**Staff Report to the
Municipal Planning Board
August 16, 2022**

MPL2022-10028

PARKWOOD APARTMENTS

DEVELOPMENT PLAN

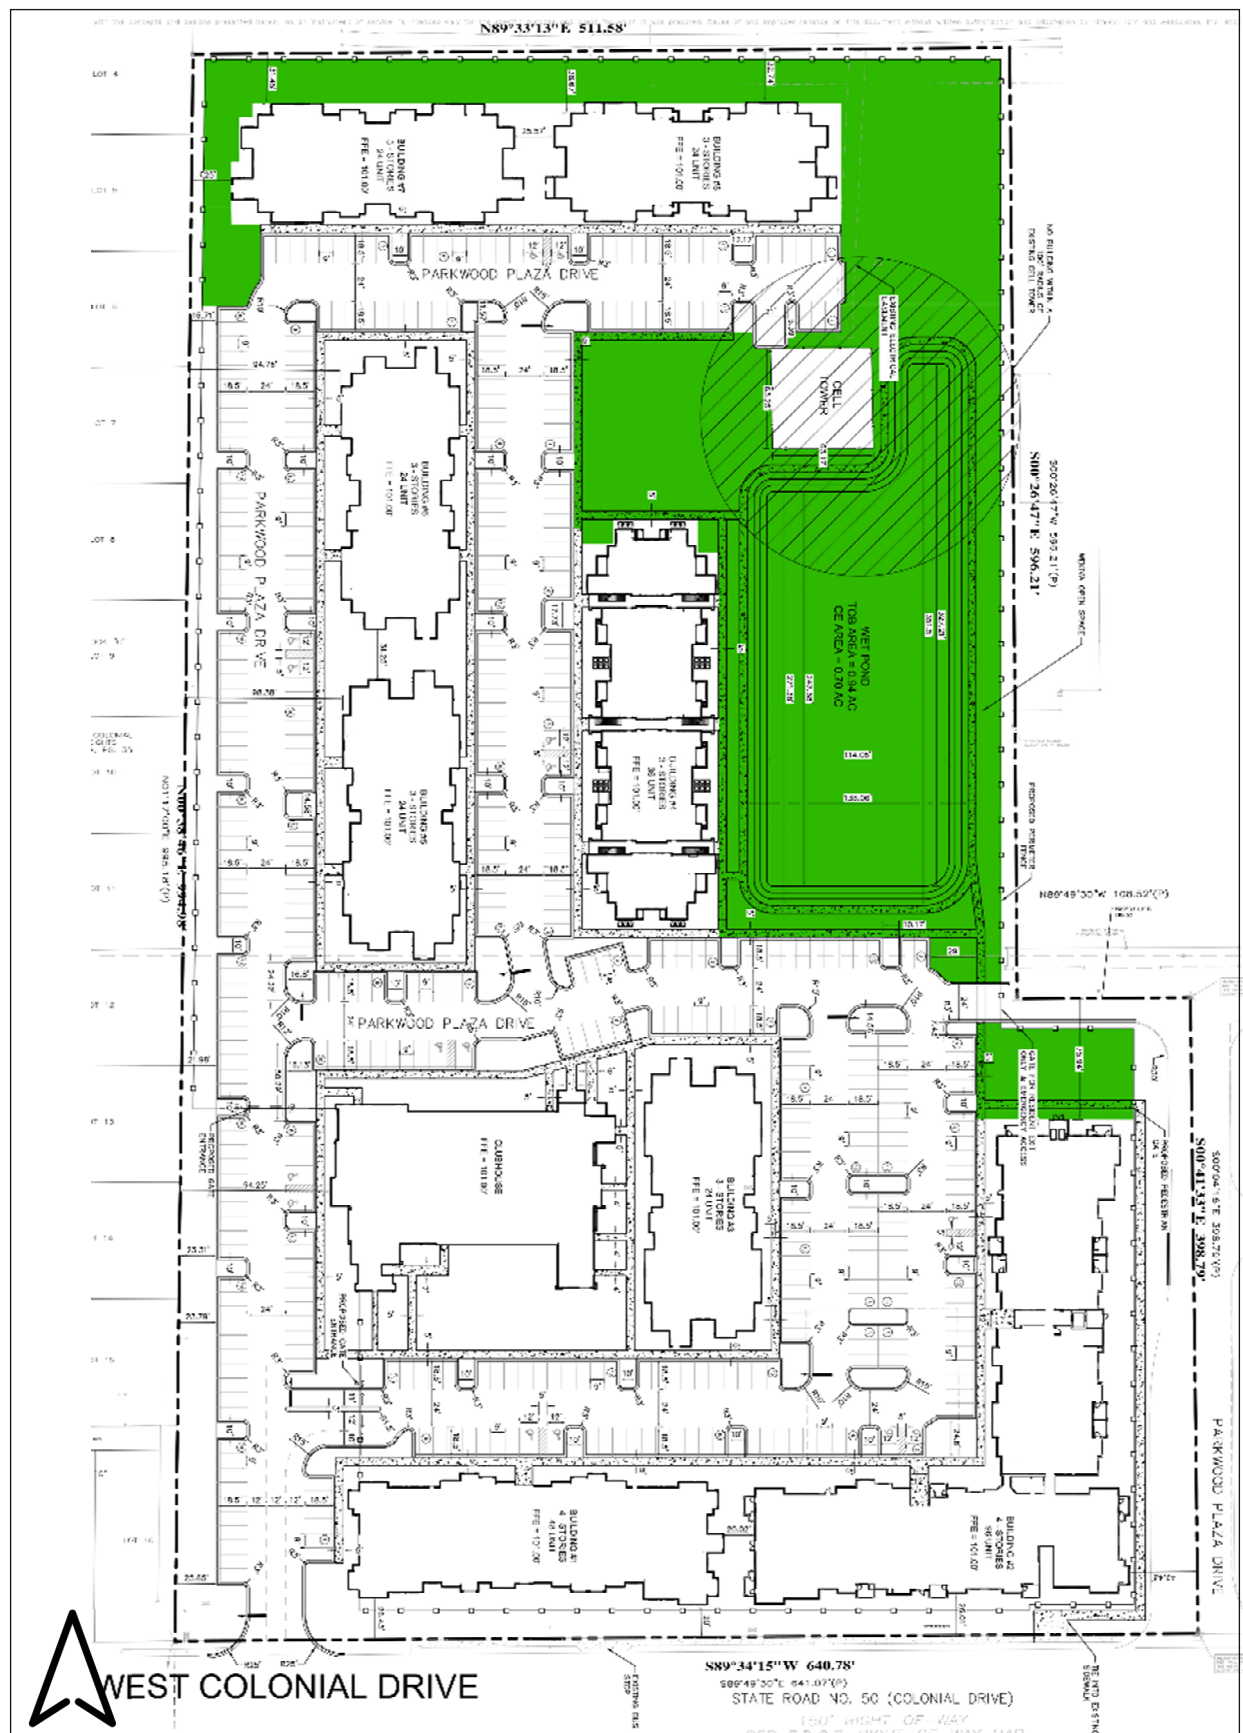
It is not clear where a trash compactor, refuse and recycling areas are located. Please provide refuse collection areas with dimensions in plans. Additionally, a 50 ft. of truck backup clearance is required. A final location for the trash and dumpster area needs to be provided at time of Final Site Plan determination.

1. Buildings 1 and 2 must provide frontage and a pedestrian connection to W. Colonial Dr.
2. Pedestrian connection should be continued from the westernmost drive aisle to the public sidewalk.

6. Currently, there is no internal continuous pedestrian connectivity. A clear pedestrian path must be provided between each building and the ROW. There should be internal crosswalks that connect each sidewalk/building.

8. Internal Pedestrian Circulation: The pedestrian circulation plan must be updated to provide connections between all buildings with the on-site sidewalks system. As shown there are many gaps between sidewalks between buildings/ across drive aisles.

10. I recommend a redesign of the site to relocate the buildings a equal distance from the residence to the west.
11. All new Multi-Family construction, Townhomes, Single Family Subdivision, change in use to residential and/or redevelopments of residential properties are required to submit a Concurrency Encumbrance letter (CEL) from Orange County Public Schools as a part of the building plan review process.

BUILDING ELEVATIONS

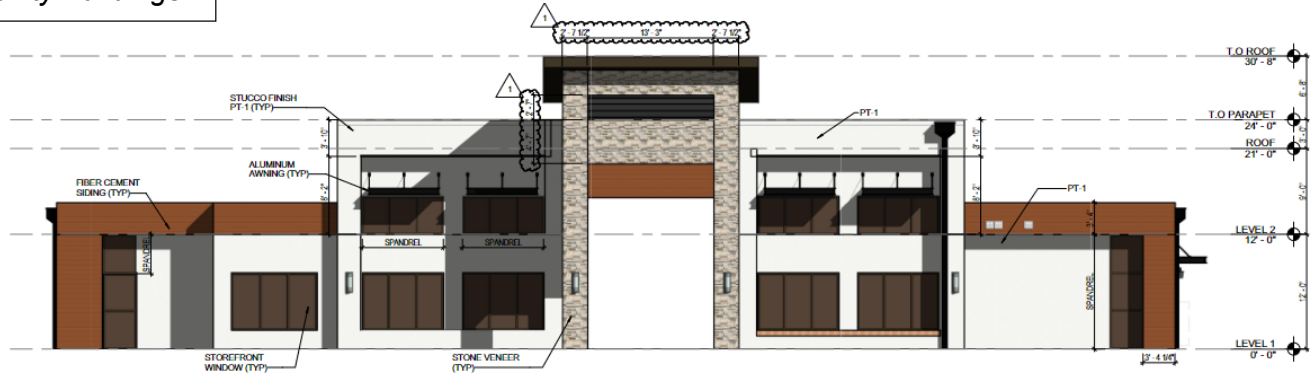
Staff is requesting that additional ornamentation and architectural treatments be added and better incorporate the architecture for the development.

1. Elevations were not provided for each building type. An appearance review prior to permitting is required. Color renderings of all four sides of each building with material call outs must be provided. Additionally, elevations should be modified to address the following conditions of approval.

2. Architectural finishes and details must be carried through on all sides of the building. The bases of buildings should be designed with durable materials to provide a quality pedestrian experience.

3. Every main entrance/breezeway is required to have a special emphasis appropriate to the architectural style of the building. Staff encourages you to use canopies or sheltering elements to highlight the entrances into the building.
